SHOREHAM NUCLEAR POWER STATION

SNRC-925

Submittal of the Conceptual Design
Modification to the Core Spray Injection
Valve Low Pressure Permissive
Shoreham Nuclear Power Station - Unit 1
Docket No. 50-322

PROPOSED MODIFICATION TO THE CORE SPRAY INJECTION VALVE

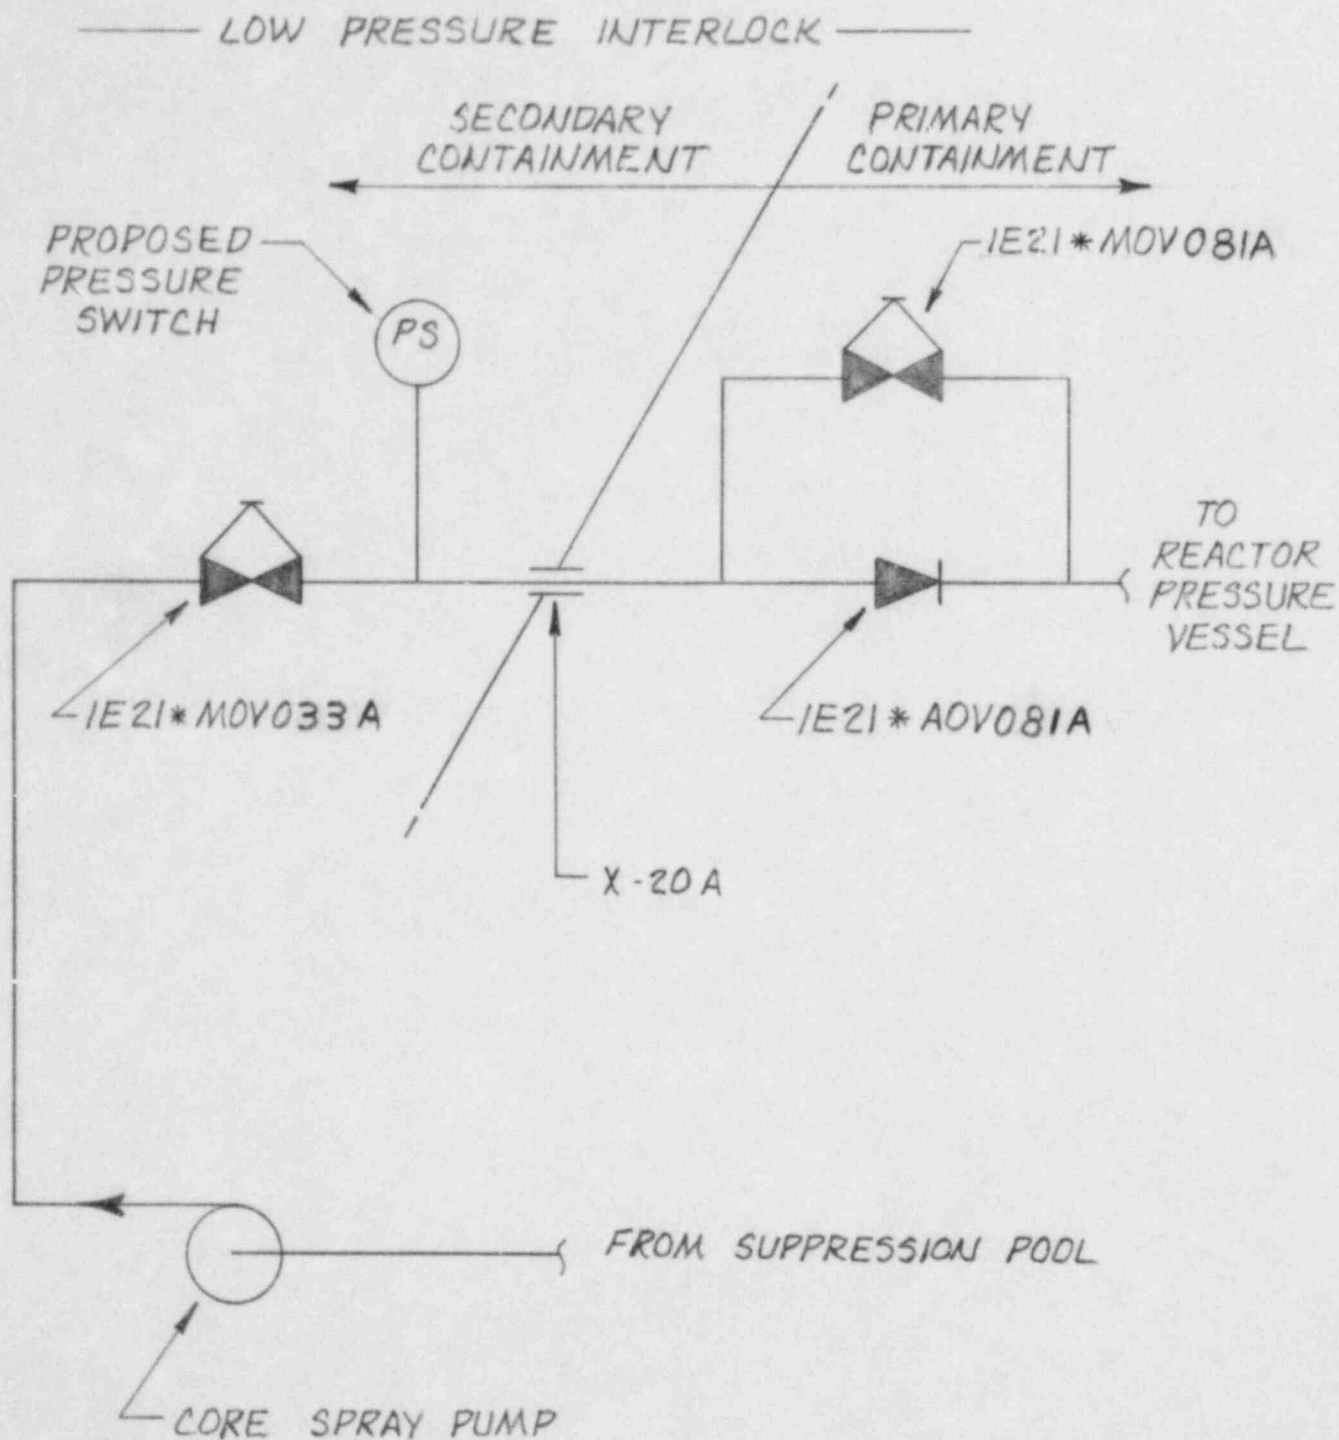
Two new pressure switches (one per loop) will be connected to the piping between the primary containment penetration (X-20A or B) and the core spray injection valve (1E21-MOV033A or B), as shown in the enclosed sketch (attachment 2). These pressure switches will be connected to the existing high pressure connection of the old differential pressure (DP) switches. The low pressure connection of the DP switch will be capped. No major wiring changes are necessary; the leads from the old DP switch will be connected to the new pressure switch. All relay logic will remain the same. The proposed injection valve opening set point is 465 psig.

If the inboard check valve (1E21*AOV081A or B) is not properly seated, the pressure switch will sense reactor pressure and prevent the check valve from opening until reactor pressure falls below 465 psig. General Electric will be requested to review this design to confirm its adequacy with regard to the FSAR Chapter 15 analyses.
